(Draft) EMS's views against JAPC's claim concerning the fault evaluations of Tsuruga PS site, EMS on shatter zones in the site of Tsuruga Power Station		JAPC's opinion	Reference No.
Main texts	Issues		
<p><EMS's views on the claim 3> (1) The operator's claim that D-1 fault is not the active fault to be taken into consideration. ➤ (Skipped)</p>	—	<p>(Original thoughts)</p> <ul style="list-style-type: none"> - Though the detected amount is small, hornblendes are broadly distributed in the same horizon while Kojaku granites or dolerites which compose the rock mass do not include hornblende. Therefore, it is considered to the amphibolite which originate in the tephra. - Although somewhat re-deposition of layer is indicated by the repeated change of amounts of amphibolite with increasing and decreasing along up and down direction, the lower occurrence limit is present on or above the bottom of layer⑤, therefore it is judged that the bottom of layer⑤ and the lower occurrence limit almost indicate the period in which the tephra was fallen. - From the points above, there is not problem in the identification method. 	—

1. Regarding geologic stratigraphic sequence of D-1 trench

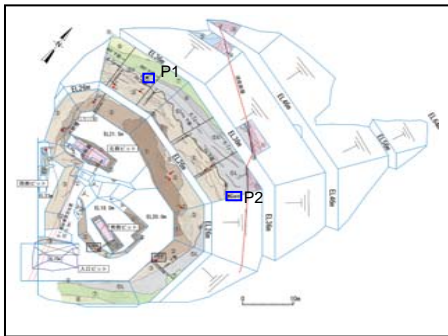
【Points to be checked with EMS】

Is there a reason that Layer ⑤ and Layer ③ are not MIS5e and MIS6 respectively, regardless of above results?

- In order to be progress of reliability, additional surveys are conducted with increasing of analysis line at D-1 trench.
- Main components of Daisen-Hiruzenpara will be investigated.
- BT37 is 127.6ka according to paper, although we couldn't confirm with sampling.

Refractive index and main ingredient analyses of hornblende in the lower part of layer⑤ and Mihama and Daisen-Matsue

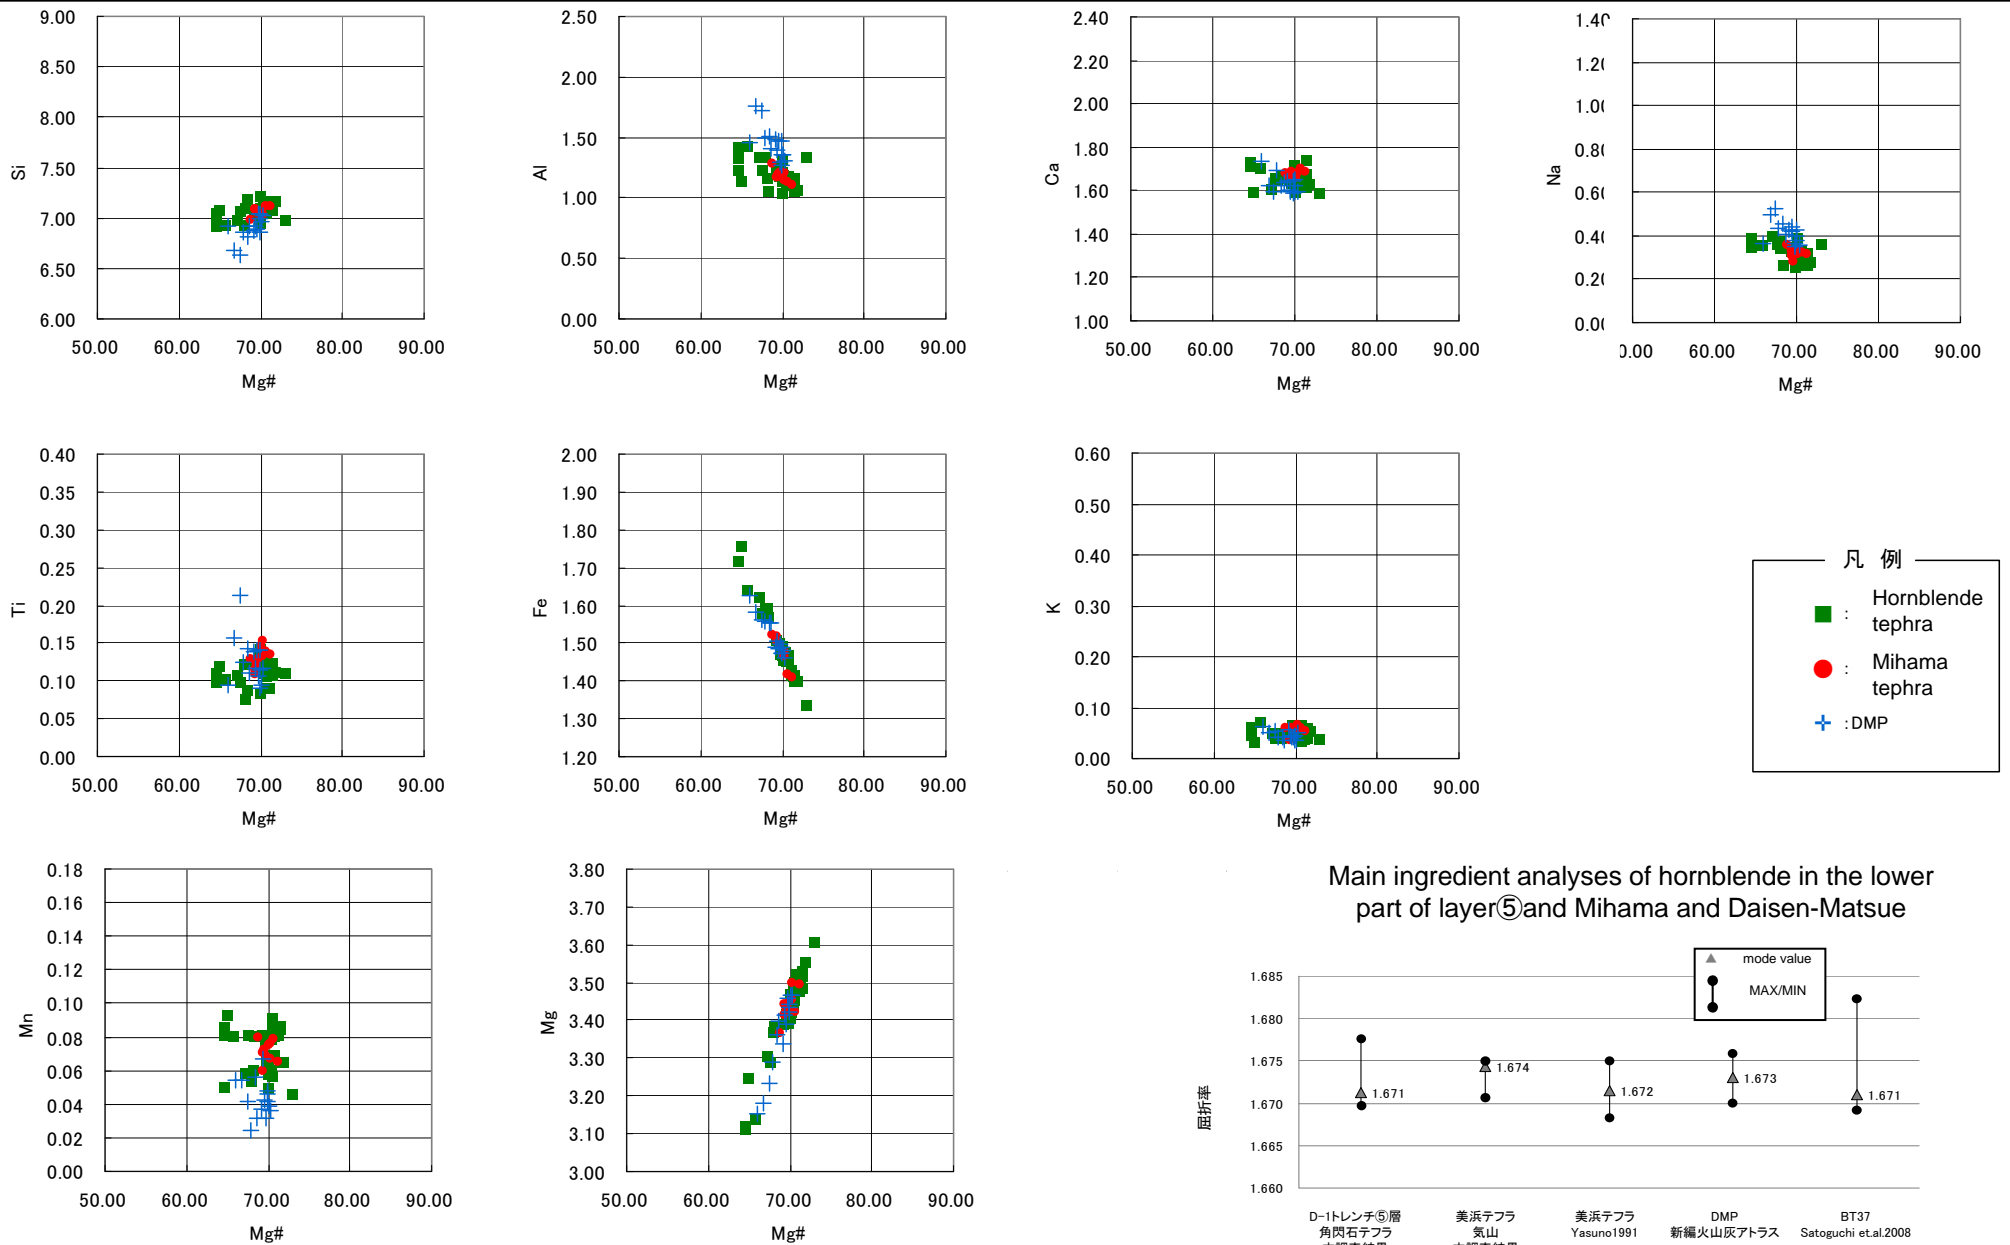
<p>(2) Identification of the tephra by analyzing minerals ➤ As for analyzing the minerals contained in tephra, it is general to compare with main components of the several types of tephra to be concerned. However, the operator determined it is the same tephra <u>only by comparing with the tephra, dating back to approx. 120 – 130 thousand years ago (the operator calls it 'Mihama tephra')</u> and the <u>identification method is considered to be insufficient.</u></p> <p>(3) Specification of the deposit which contains the tephra ➤ Since the content percentage of the mineral (amphibolite) detected by the lower part of layer⑤ is <u>low frequency which is less than one per 3,000 counts, and small amount of the mineral (amphibolite) are included in layer③</u> that is lower level, the operator's claim that the lower part of layer⑤ is deposited with the tephra, dating back to 120 – 130 thousand years ago is not reliable assumption. ➤ In order to specify the layer in which the tephra is deposited, it is preferable to recognize volcanic ashes by checking them with eyes. If it is not available with the eye inspection, there is also a way to specify the age, applying the method to count the minerals contained in the tephra in the layer. In that case, <u>it is difficult to specify the layer in which the tephra is deposited unless large amount of minerals are contained in the layer while there is significant difference between the upper and the lower layers.</u></p>	<ul style="list-style-type: none"> - The result of main components analysis has only been compared with Mihama tephra. - The contents of the minerals is low frequency, and it cannot be specified as the layer in which the tephra is deposited unless there is a significant difference between the upper and the lower layers. - Amphibolite is also included in layer③. 	<p>(Outline of today's explanation (new data))</p> <ol style="list-style-type: none"> 1. Stratigraphy of D-1 trench => Layer⑤ was deposited in the warm period, while deposit period of layer③ was colder than layer⑤. 2. Regarding hornblendes included in the lower part of layer⑤ and layer③ => Significant difference has been recognized between the hornblende in lower part of layer ⑤ and the one in layer③ in a result of main composition analysis, although mineral products are quite little because they are gravel. => It was identified that the hornblendes produced in the specific layer of the lower part of layer③ was the amphibolite which originated in the tephra. => It was identified that the lower part of layer⑤ was not the re-deposition of layer③ . 3. Hornblendes detected in the lower part of layer⑤ => There is a high possibility that the hornblendes in the lower part of the layer⑤ is Mihama tephra. => Daisen-Hiruzenpara and BT37 are distributed lower than Sanbe-Kisuki (110-115Ka), which are the tephra, deposited in the marine isotope stage 5e. => Therefore, it is considered that the lower part of layer⑤ should be the deposit of the marine isotope stage 5e. => Layer③ is deposit in marine oxygen isotope stage 6 or before, with consideration that layer③ is lower and colder than layer⑤. <p>In addition,</p> <ul style="list-style-type: none"> - additional analyses are implemented by increasing the survey lines in the D-1 trench in order to be progress of the reliability. - the main components are to be identified as for Daisen-Hiruzenbara. - BT 37 is 127.6ka according to the existing literature though it cannot to be confirmed as it is difficult to obtain the sample. <p>(Points to be clarified by EMS)</p> <ul style="list-style-type: none"> - Considering the above, is there still the reason that the lower part of layer⑤ and layer③ are not respectively MIS5e and MIS6? - The EMS confirmed that the geologic layer where the deformation of the K fault ran up did not reach to the silt layer of layer③. 	61-78

Comparing main components analyses of hornblende of layer⑤L with the ones of Daisen-Matsue and Mihama, the hornblendes of the lower part of layer⑤ and Mihama have close resemblances.
